**CITY OF SAN ANGELO
SAN ANGELO LANDFILL
TOM GREEN COUNTY, TEXAS
TCEQ PERMIT NO. MSW 79**

**SITE DEVELOPMENT PLAN
AND
PERMIT MODIFICATIONS
(THROUGH DECEMBER 2013)**

Modification to Municipal Solid Waste Permit No. 79 San Angelo Landfill

MODIFICATION TO MUNICIPAL SOLID WASTE PERMIT NO. 79 CITY OF SAN ANGELO LANDFILL

REVISIONS						DSN.	KJW	DATE	07/07	ATTACHMENT
1	11/07	ADDENDUM	WCM	ALN	KJW	DWN.	RMP	SCALE	GRAPHIC	3A.5
REV	DATE	DESCRIPTION	OWN	BY	DES BY	CHK	KJW	DWG	LinerDetails.dwg

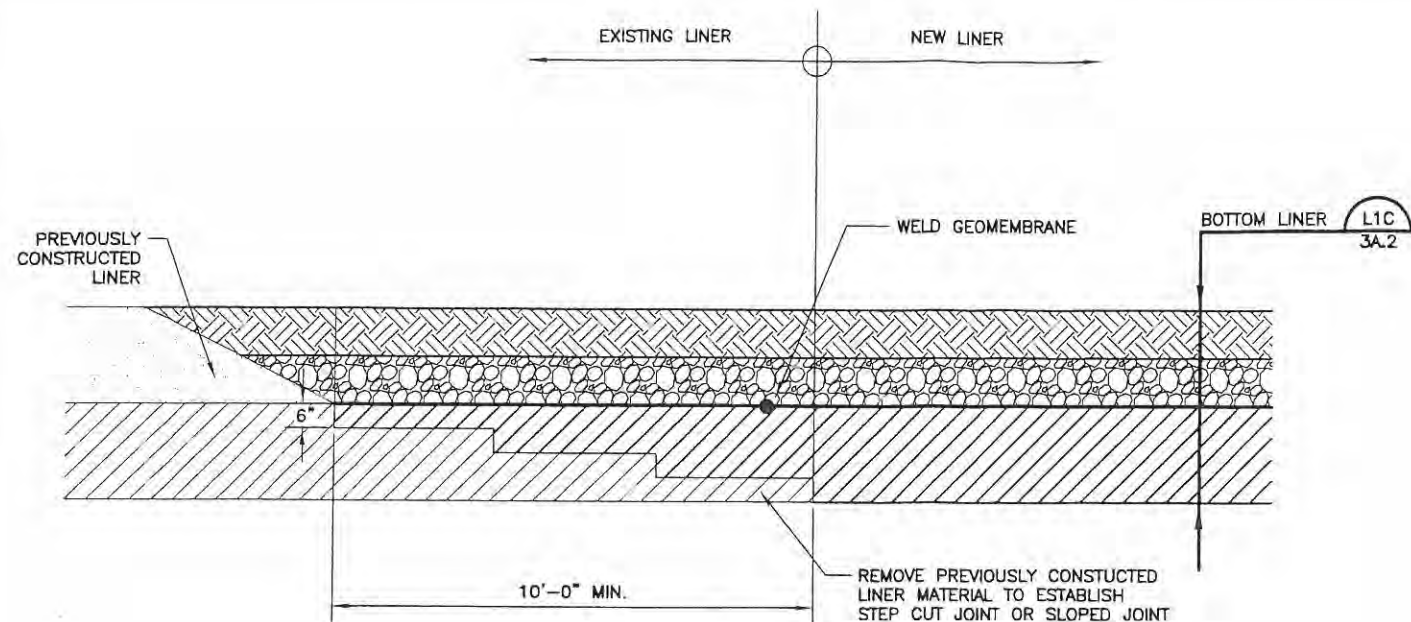
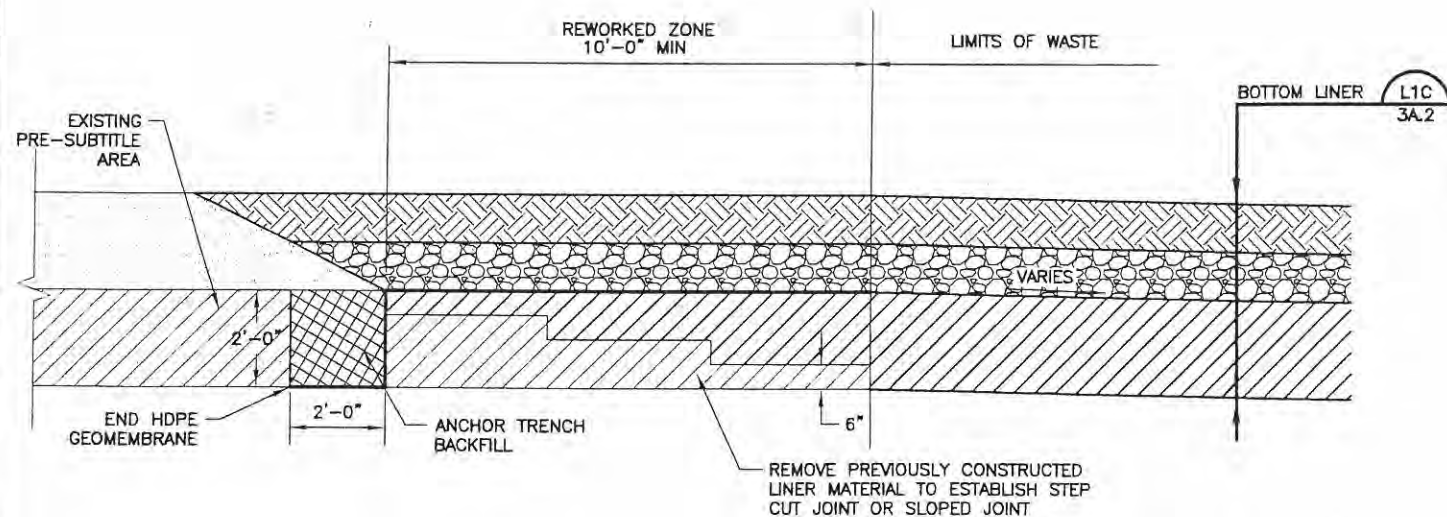
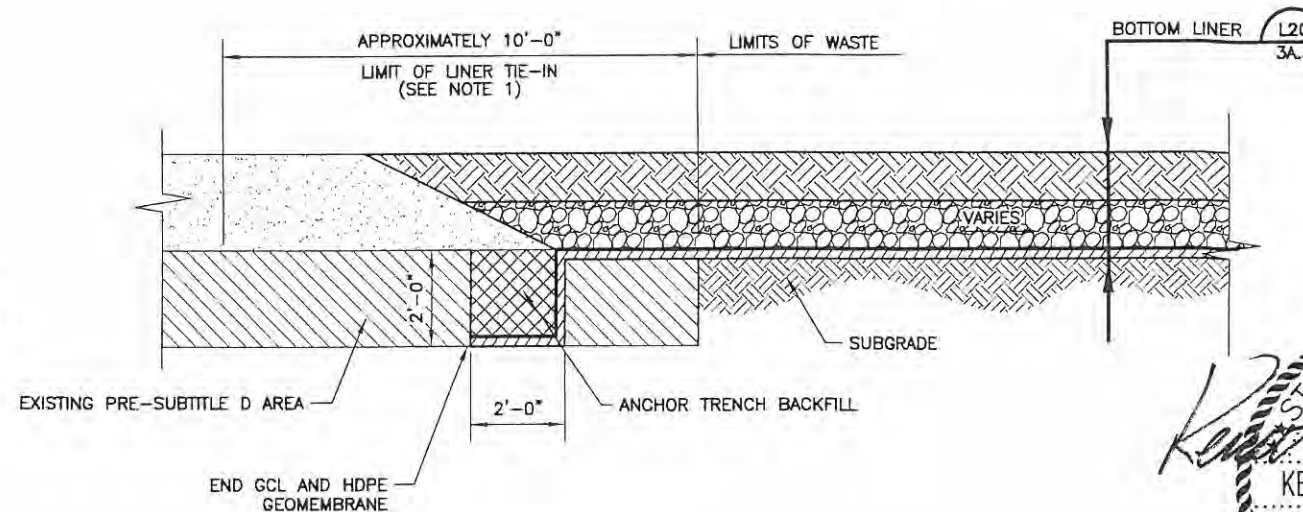
Per our telephone conversation on November 15, 2007, we are submitting an addendum to the Soils and Liner Quality Control Plan Permit Modification. The Soils and Liner Quality Control Plan Permit Modification was submitted to TCEQ on July 2, 2007. As requested, Detail L6A (Liner Tie-In to Pre-Subtitle D Area) on Attachment 3A.5 has been revised to provide additional callout descriptions and dimensions.

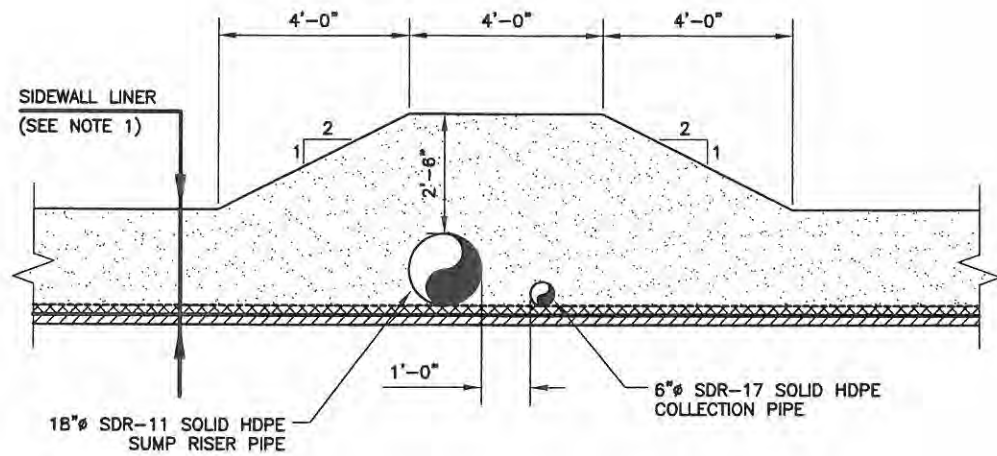
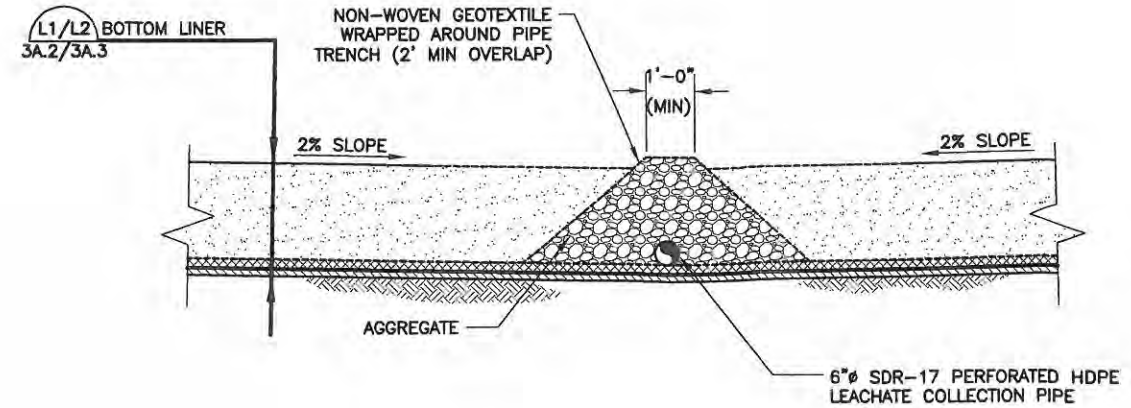
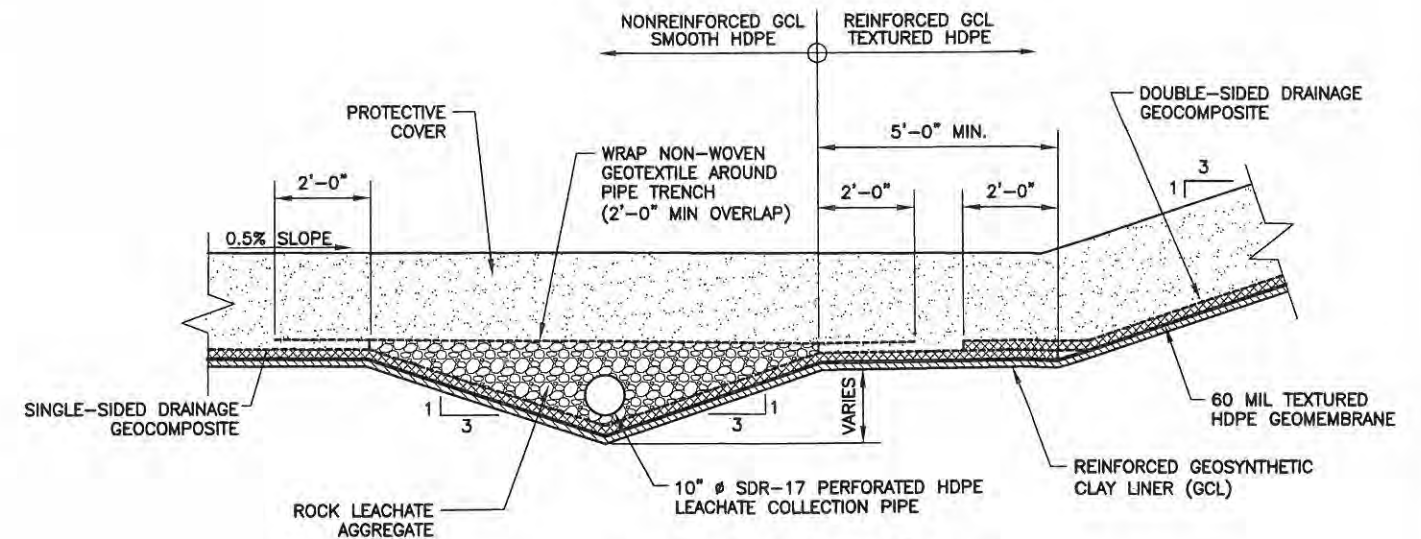
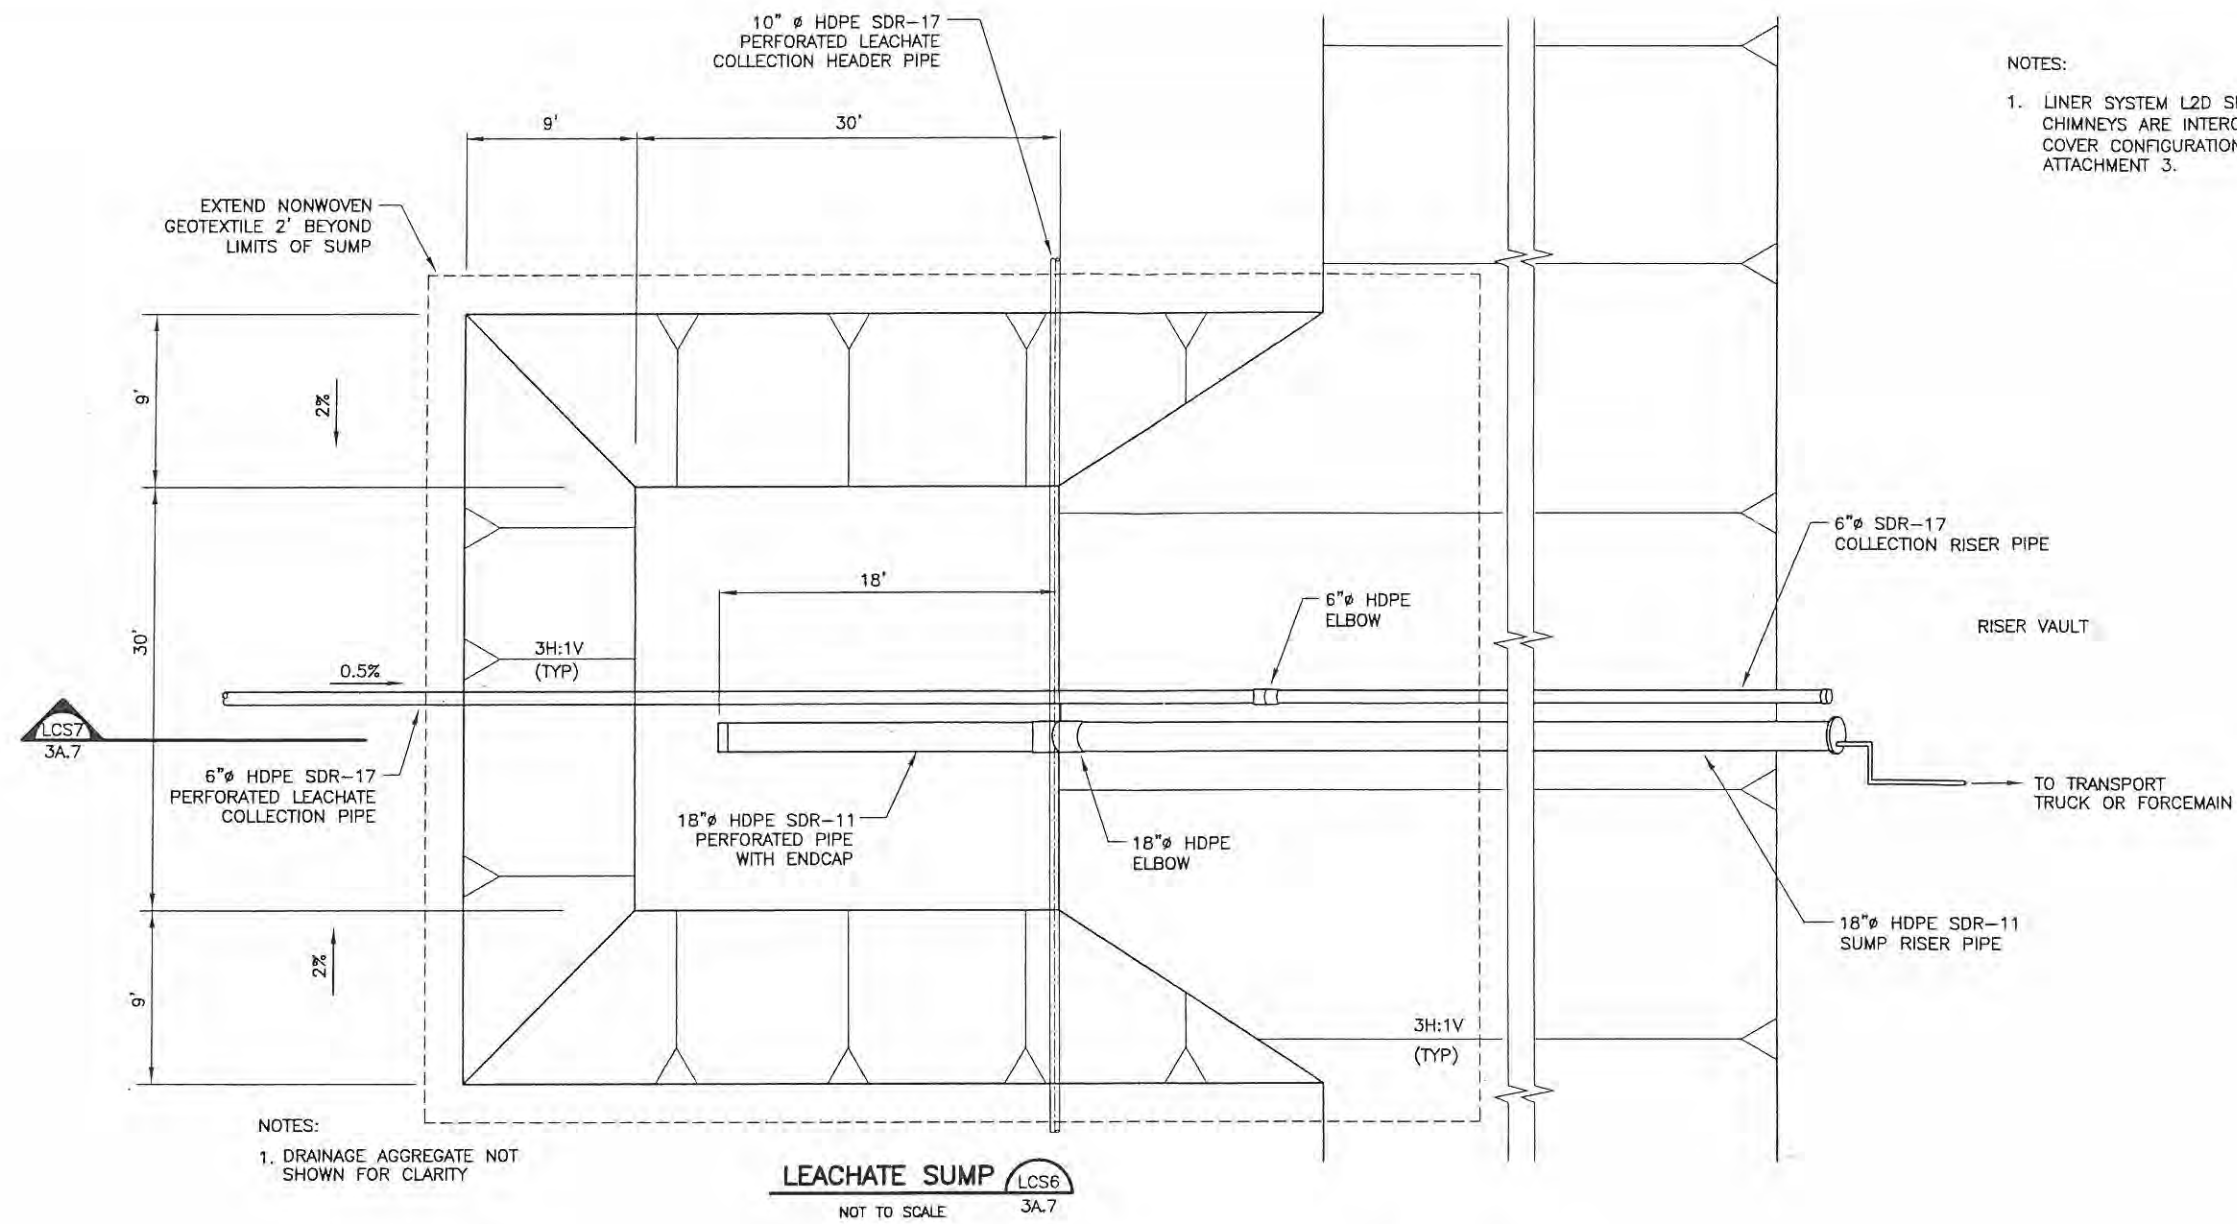
This modification revises Attachments 2, 3, and 10 of the referenced permit, changing the minimum required width of leachate chimneys and correcting inconsistencies between attachments.

Attachment 3A.6 (drawing)

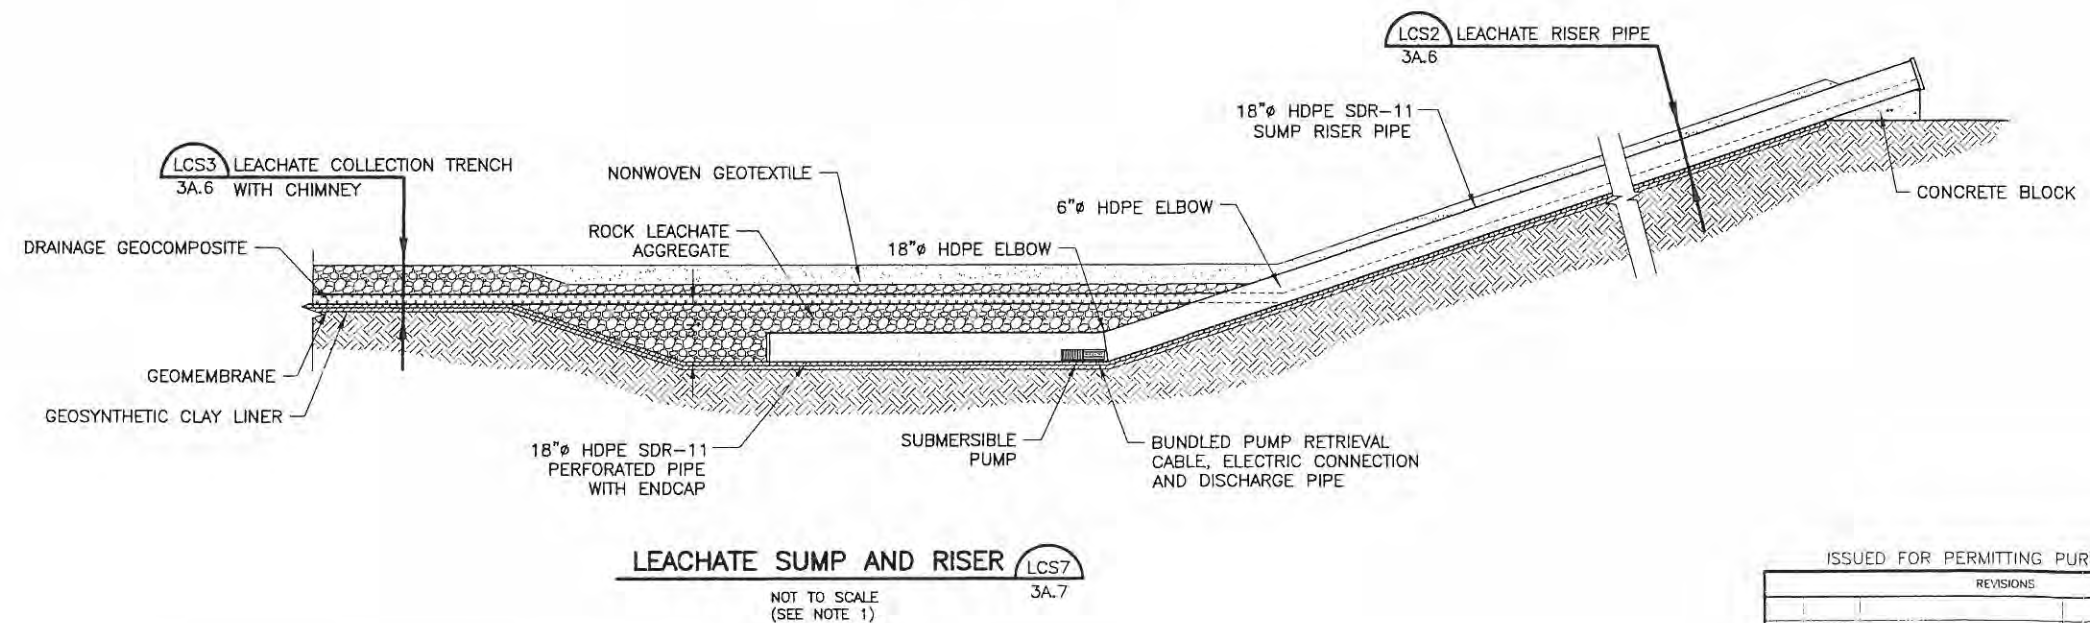
1. Part III, Site Development Plan, Attachment 2, Title Page.
2. Part III, Site Development Plan, Attachment 2, Table of Contents, Page ii.
3. Part III, Site Development Plan Drawing Nos. 94-05, 94-06A, 94-09, 94-09A, 94-10, 94-10A, 94-11.
4. Part III, Site Development Plan, Attachment 3, Appendix 3A, Attachments 3A.1, 3A.6, and 3A.7.
5. Part III, Site Development Plan, Attachment 10, Complete Replacement.
